Groundwater Application Review Summary Form

Application # ~~G~~^{LL-} 1812

PUBLIC INTEREST REVIEW FOR GROUNDWATER APPLICATIONS

TO: Water Rights Section Date January 27, 2020
 FROM: Groundwater Section Travis Brown
 Reviewer's Name
 SUBJECT: Application LL- 1812 Supersedes review of _____
 Date of Review(s)

Thisis (1935) Drawdown Analysis at MARI 68801

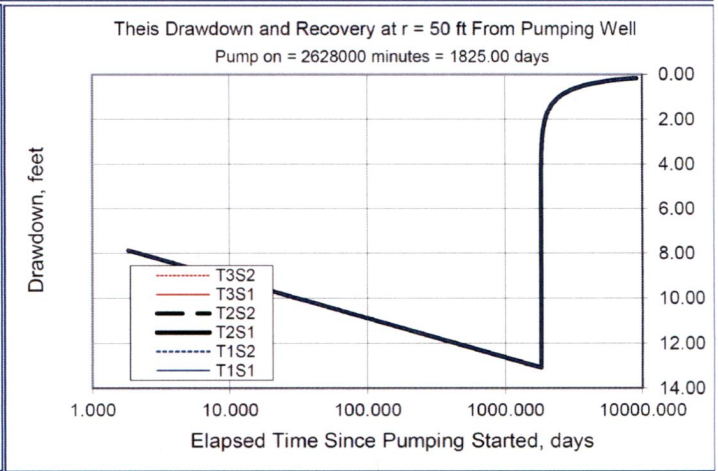
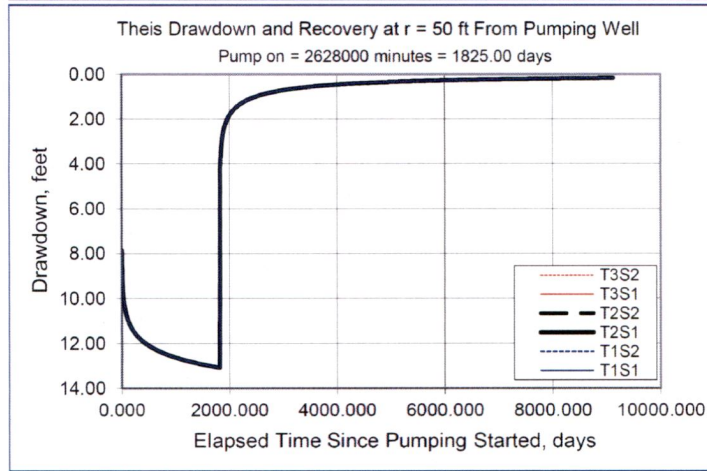
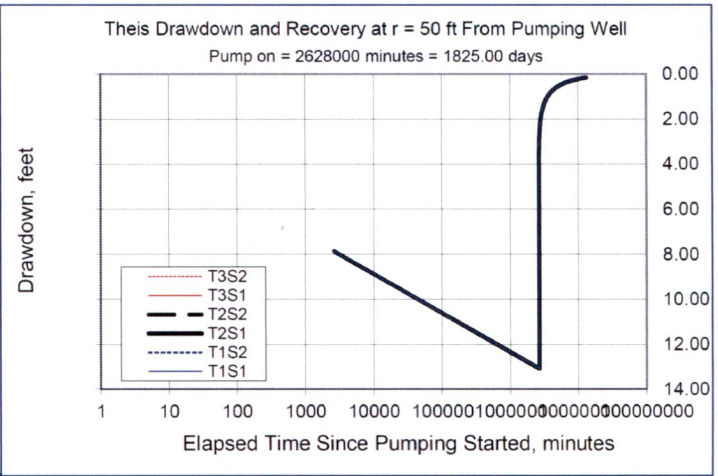
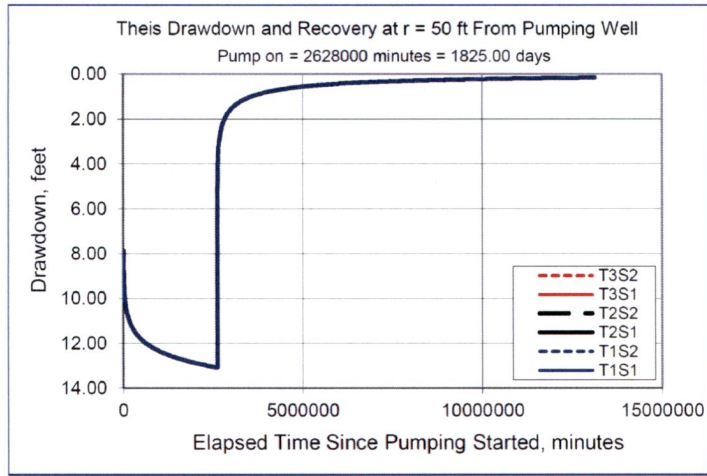
The nearest basalt well to the proposed POA appears to be MARI 68801, an exempt use domestic well located on Tax Lot 1600 to the southwest of the proposed POA; however, an exact location for MARI 68801 is not available. In order to assess the potential for well-to-well interference, a Theis (1935) drawdown analysis was conducted (see attached Theis Drawdown Analysis at MARI 68801). Hydraulic parameters used for the analysis were derived from regional data and studies (Pumping Test Reports; Conlon et al., 2005; McFarland and Morgan, 1996; Reidel et al., 2002; Woodward et al., 1998) or are within a typical range of values for the given parameter within the hydrogeologic regime (Domenico and Mifflin, 1965; Freeze and Cherry, 1979). To be conservative, it was assumed that the proposed POA would pump at its maximum requested rate (0.22 cfs) continuously (24 hr/day, 365 day/year) over the entire requested period of the limited license (5 years); additionally, because the exact location of MARI 68801 is not available, drawdown was assessed at the radial distance between the proposed POA and the nearest property line of Tax Lot 1600 (~50 ft). Under the standard condition for basalt aquifers in the Willamette Basin, Condition 7i, the requested use would need to be curtailed if hydraulic interference exceeded 15 ft in any neighboring well providing for senior exempt uses or covered by prior rights. **However, results of the drawdown analysis indicate that, even under the highly conservative scenario outlined above, drawdown from the proposed use is not anticipated to exceed 15 ft within the requested period of the limited license.**

Hydrographs

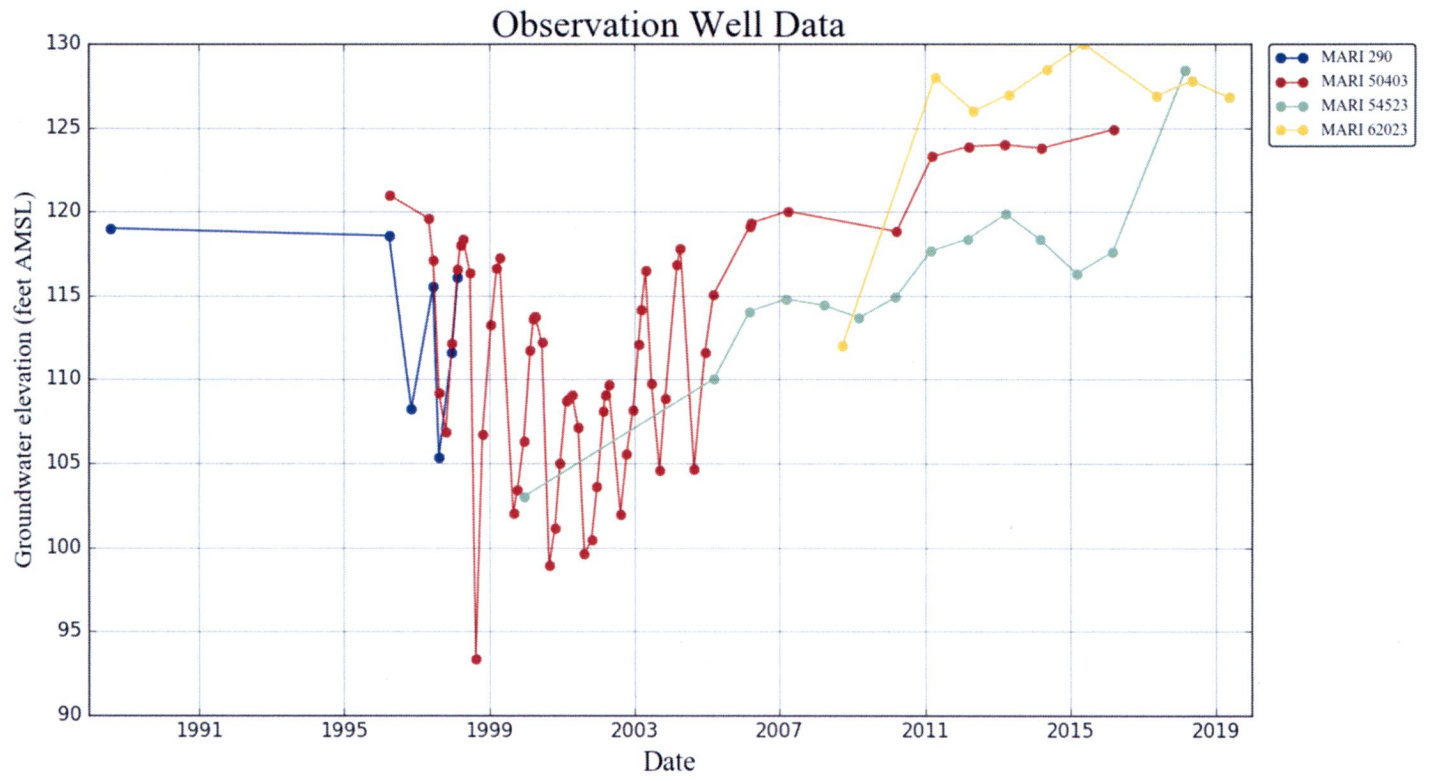
Water availability data for the CRBG aquifer(s) in the area of the proposed POA is limited. The nearest observation wells with relevant data (MARI 50403 and MARI 54523) are ~4000-5000 ft southwest of the proposed POA, within the outcrop/subcrop area of CRBG surrounding La Butte. Neither of these wells show progressive declines within the past decade (see attached Hydrograph). However, the proposed POA is less than 3,700 ft outside of the boundary (northwest bank of the Willamette River) of the Sherwood-Dammach-Wilsonville Ground Water Limited Area (OAR 690-502-0190), which is classified for exempt uses only. **As such, there are significant concerns about the potential for future water level declines in the CRBG aquifer(s) in this area. To avoid injury to senior groundwater users and the groundwater resource, the Conditions specified in B1(d)(i), B2(c), and B3 (Special Conditions) are recommended for any permit issued pursuant to this application.**
